JVC

SERVICE MANUAL

KD-LX50

Supplement

General assembly

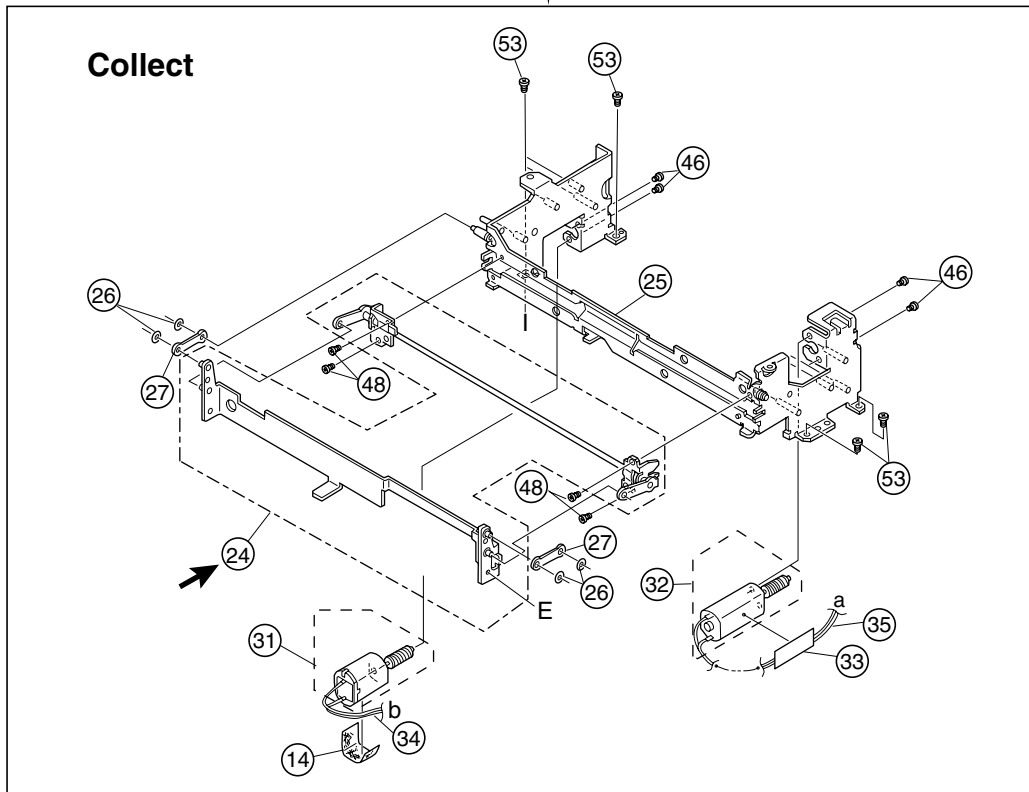
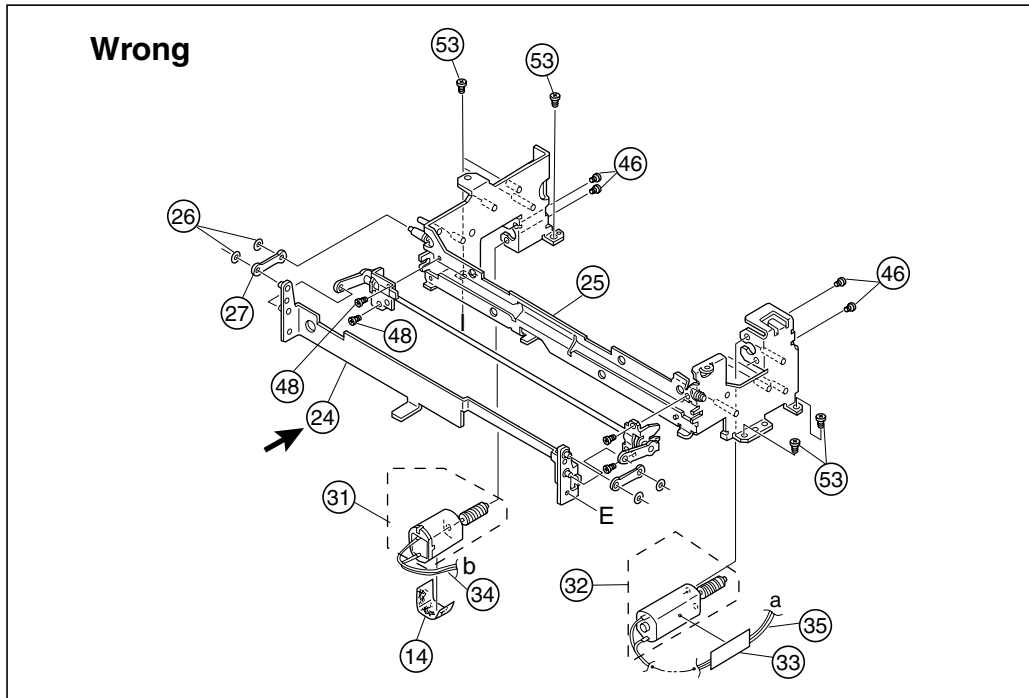
General assembly indication was wrong.
Please change the service manual of KD-LX50.
(Issue No.49561)
